A47 North Tuddenham to Easton Dualling

9.29 Applicant's Written Summary of Oral Submissions at ISH3

**APPLICANT'S WRITTEN SUMMARY OF ORAL SUBMISSIONS
AT ISH3**

Regulation Number:	Rule 8(1)(c)
Planning Inspectorate Scheme Reference	TR010038
Application Document Reference	TR010038/EXAM/9.29
Author:	A47 North Tuddenham to Easton Project Team, Highways England

APPENDIX A - Updated Cross-Section Drawings, Originally Submitted With The Applicant's Response To The Examining Authority's Third Written Questions (REP6-018).

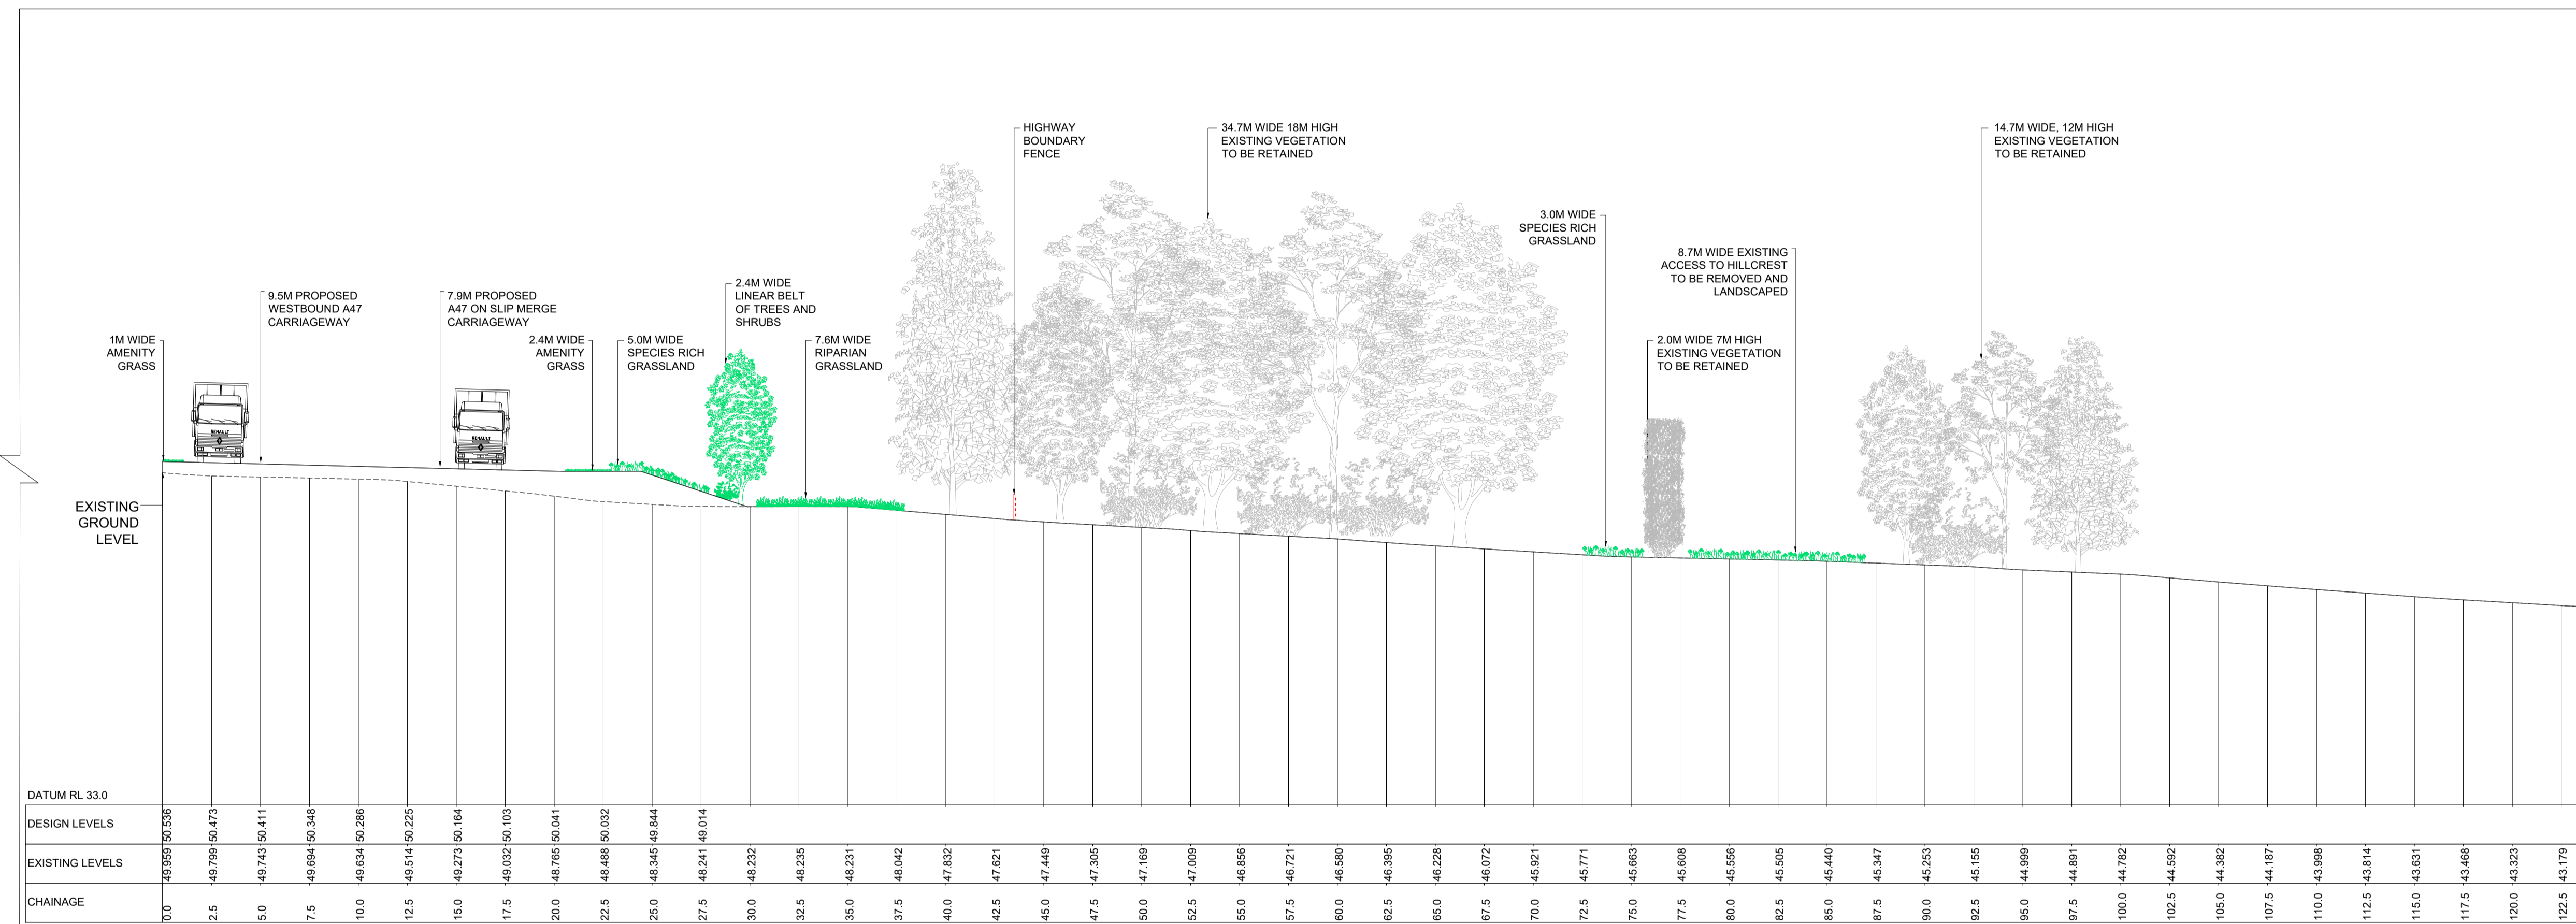
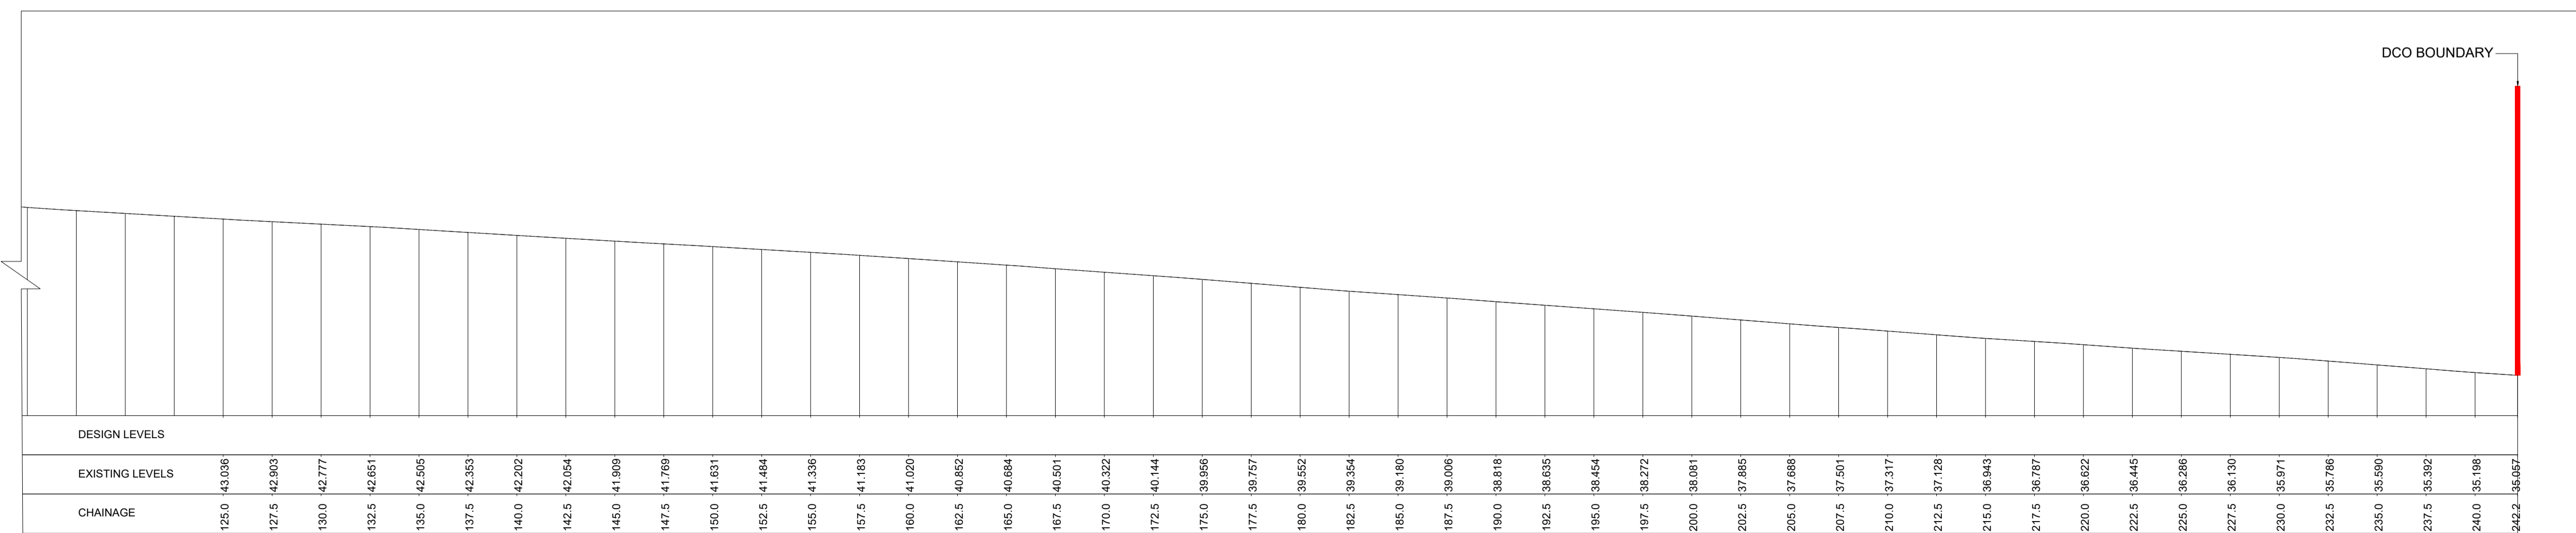
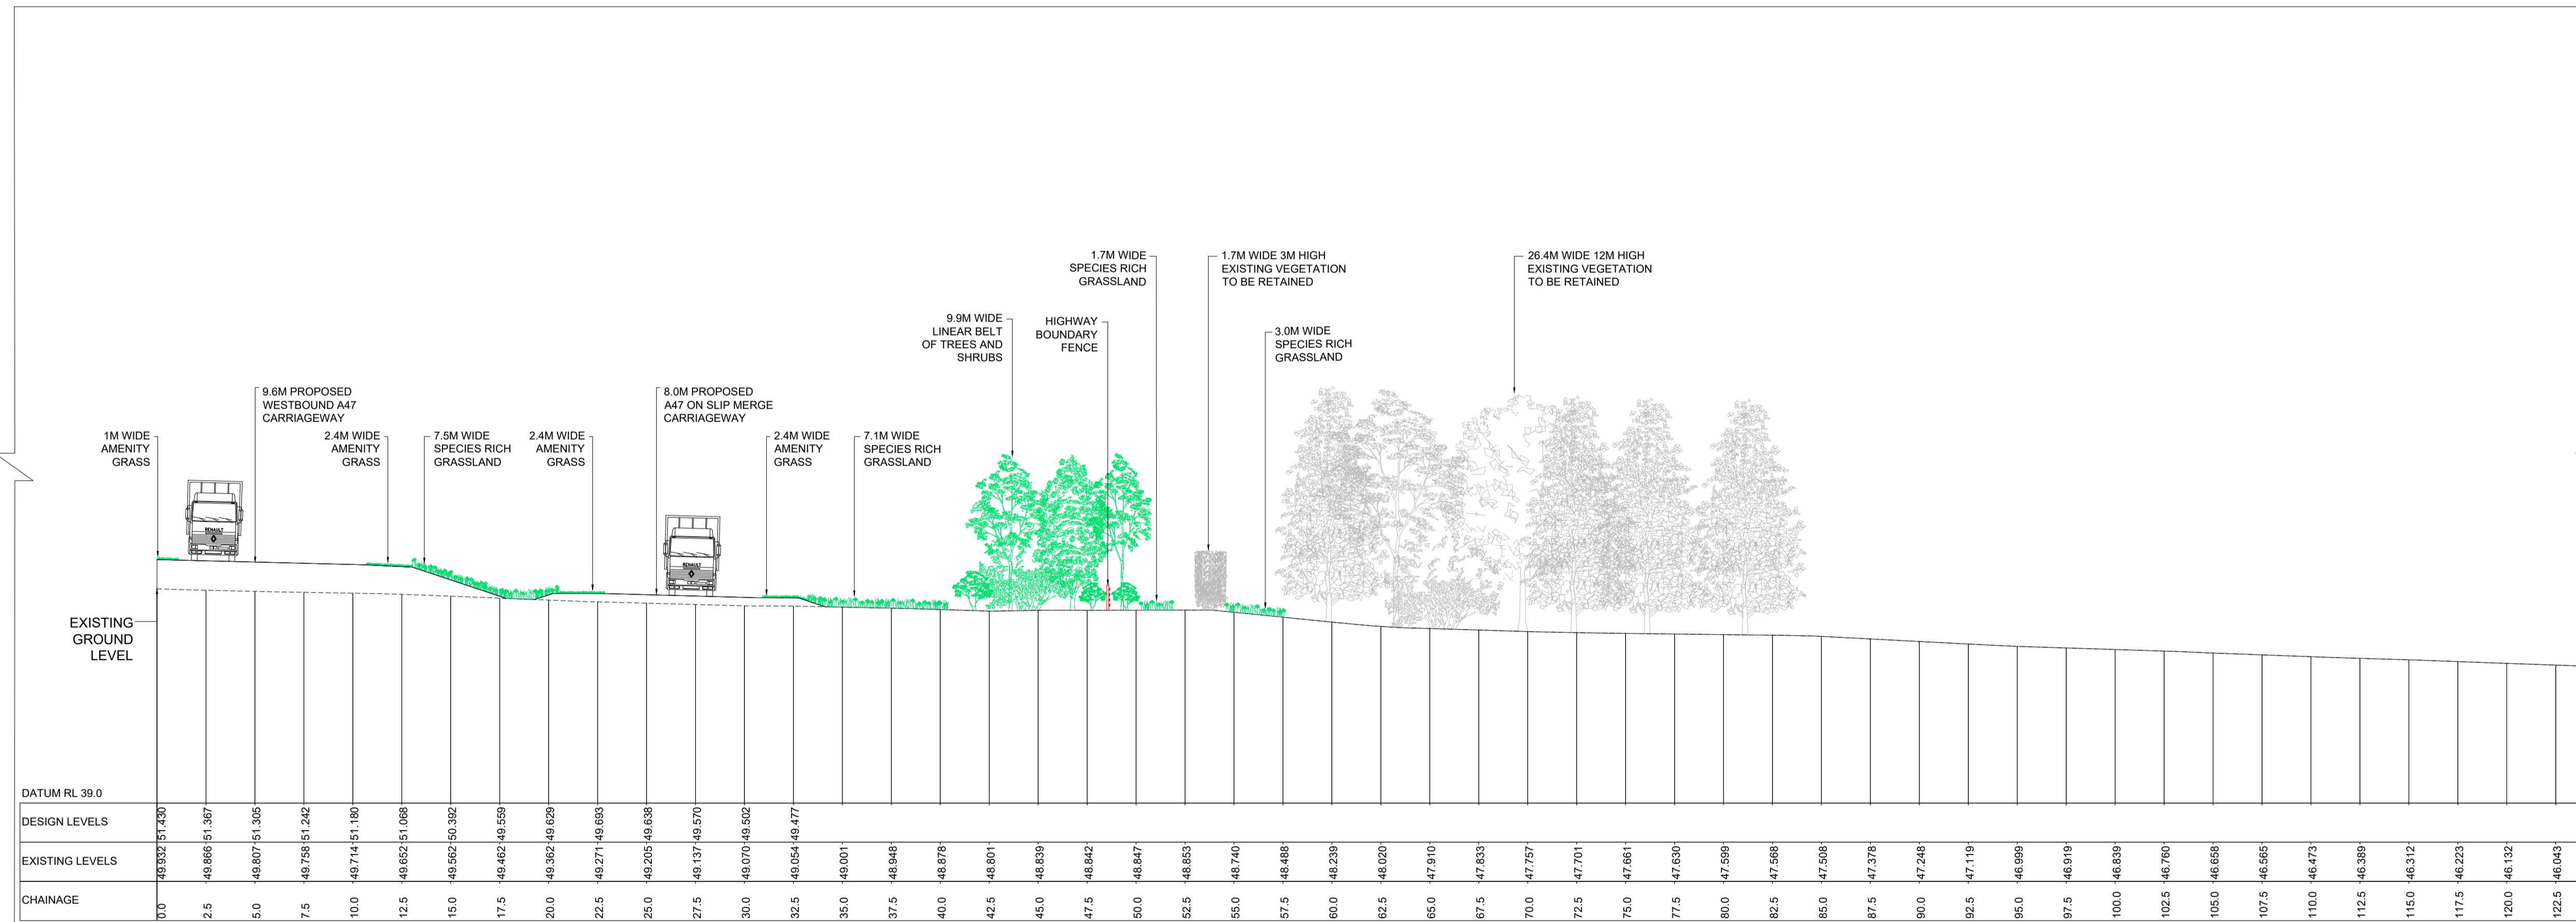
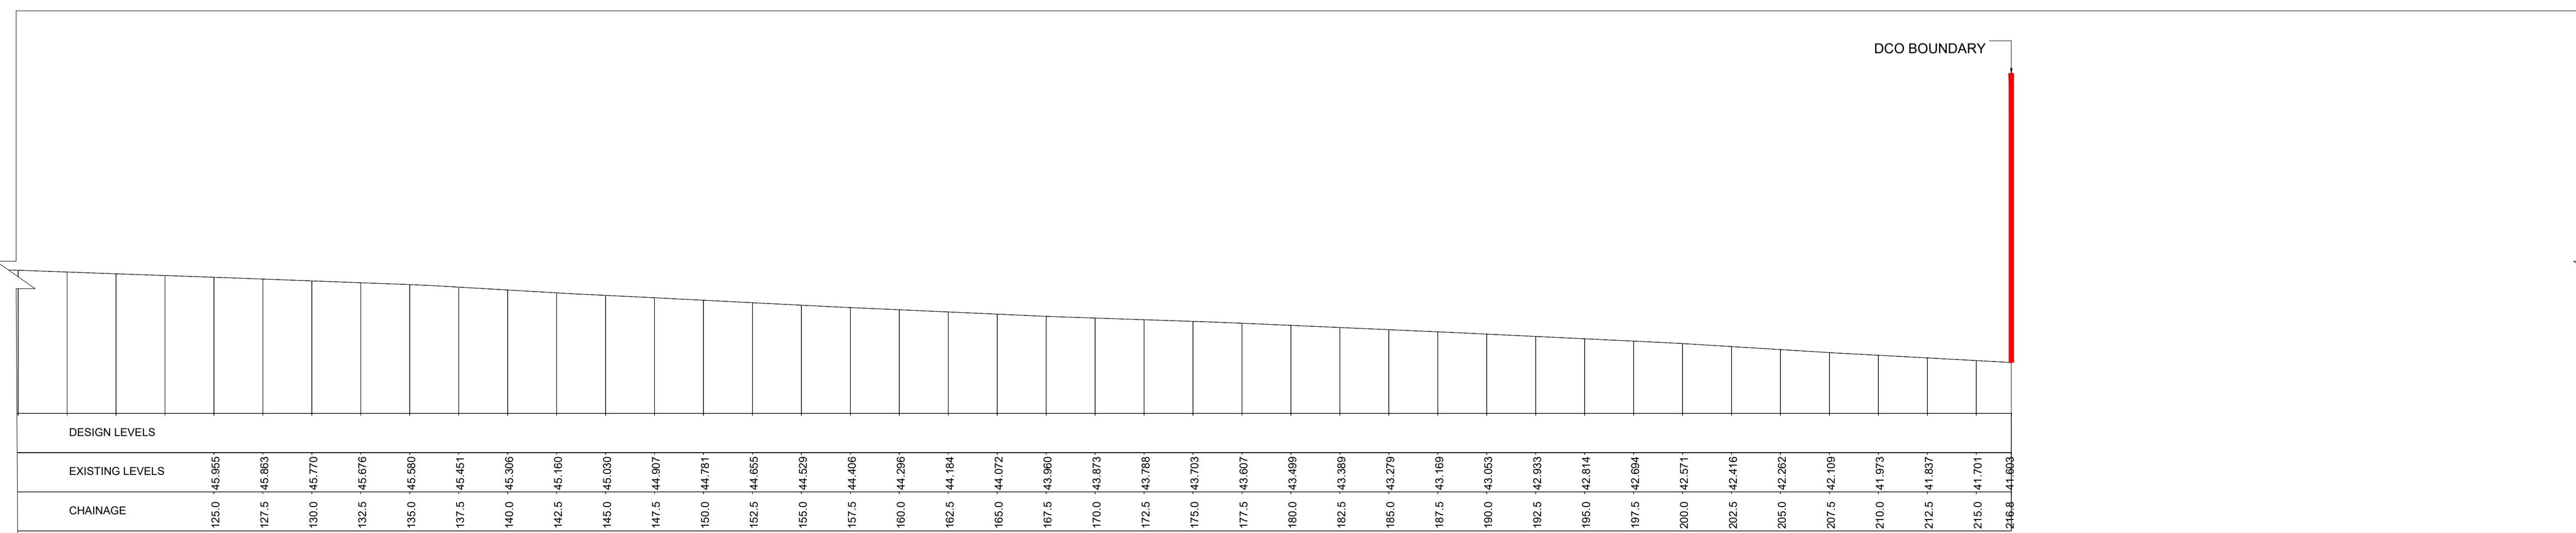
41.	<p>The ExA highlighted a question raised in a previous ISH in relation to the methodology used for cross-sectional drawings.</p> <p>The ExA also queried whether any lighting columns are shown on the cross-sections.</p> <p>George Josselyn asked if it would be possible to delineate the existing trees with those proposed by a change in the colouring and if a line could be drawn showing the limit of the permanent acquisition of land on the cross-section.</p>	<p>The Applicant stated that it would respond in writing to this question with a brief methodology on the preparation of the cross-sections Mr Josselyn referred to.</p> <p>The cross-sections were produced in line with the latest information and data, including topographic data, arboricultural data and the arboricultural masterplan (REP3-016) and are intended to show the scheme planting at a reasonable level of maturity. The existing (retained) trees are shown using data from the arboricultural assessment which makes the retained trees as accurate as possible on the sections.</p> <p>In relation to the lighting columns the Applicant stated that there are no lighting columns that directly dissect the section lines but that the Applicant will include indicative columns within areas to be lit to indicatively illustrate their relative scale and location.</p> <p>In relation to the cross-section drawings the Applicant highlighted that the limit of permanent acquisition is shown by reference to the Highway Boundary Fence. Existing vegetation has also already been annotated on the plans.</p>	<p>Appendix A of this ISH3 hearing note contains updates to the cross-section drawings submitted as Appendix A to the 'Applicant's Response to the Examining Authority's Third Written Questions' (REP6-018). The approach to producing the cross-sections was as follows:</p> <ul style="list-style-type: none"> • The location of the sections was selected to give a range of illustrative material within the vicinity of the proposed junctions and based on a request from the landowners agent for sections at chainages through the road centreline and southwards into Berry Hall Estate. The Applicant reviewed the chainages and provided sections as required including an additional section (Section F-F) not requested by the landowner. • The sections were produced using the Scheme design submitted for Examination, existing topographical survey data and exported from the 3D modelling software.

Ref	Questions / Issues Raised at ISH3 and Hearing Action Points	Summary of Applicant's Response at ISH3	Applicant's Written Response
		<p>The applicant will update the visual representation of existing/proposed vegetation and the freehold boundary in a re-issue of the sections.</p>	<ul style="list-style-type: none"> • The retained existing tree cover is illustrated as accurately as possible, utilising project arboricultural information (refer to APP-094, Appendix 7.6). The height of retained existing trees is represented utilising surveyed heights from the arboricultural report, but does not account for future growth post that survey. • As part of the Scheme, the following key components are also shown: <ul style="list-style-type: none"> - Proposed mitigation planting. Planting information is taken from the Environmental Masterplan (AS-007) and is shown at 8m above proposed ground level, therefore linking to Table 7-6 of EIA Chapter 7 (APP-046) which defines planting heights at Year 15 of operation of the Scheme. - The proposed highway boundary is shown by inclusion of the "Highway Boundary Fence". - Indicative locations of lighting columns are shown at 10m in height, as assessed in the EIA. - Vehicles on the Scheme are shown at a maximum of 4m in height (above road level), the tallest vehicles being lorries.
